FRAM ANNOUNCES PRODUCT IMPROVEMENTS TO THE PH3976

***EFFECTIVE 4/23/01 FOR FERNLEY
CUSTOMERS AND 4/30/01 FOR ALL
OTHER CUSTOMERS, THE PH3976
WILL BE SUPERCEDED TO THE
PH3976A***

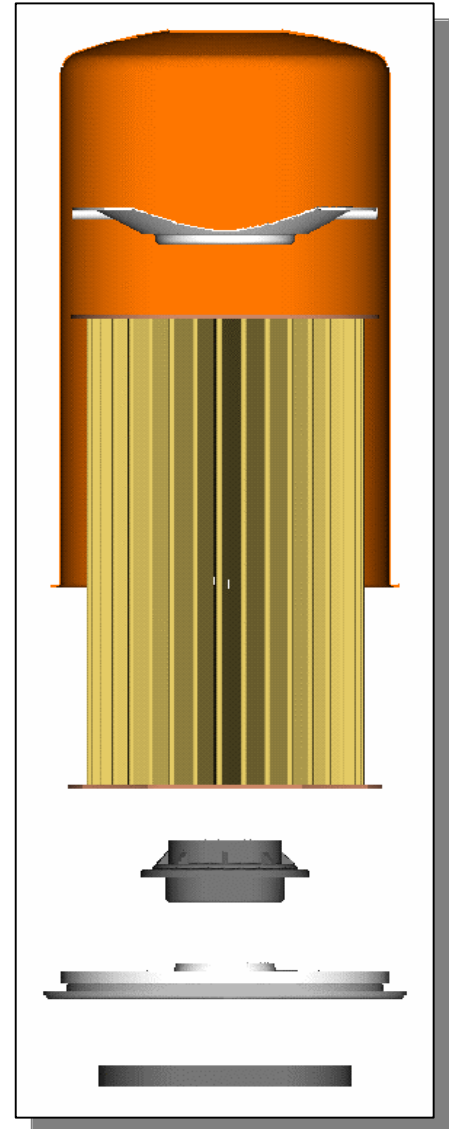
Several important product improvements have been made to the PH3976A:

- The cartridge has been upgraded to contain a spiral center tube.
- The retainer spring is more robust. 23% thicker and stronger material.
- A plastic centertube seal has been added between the centertube and the tapping plate. This improvement creates a better seal between the filter cartridge and the tapping plate

These product improvements result in a more
robust filter than the PH3976
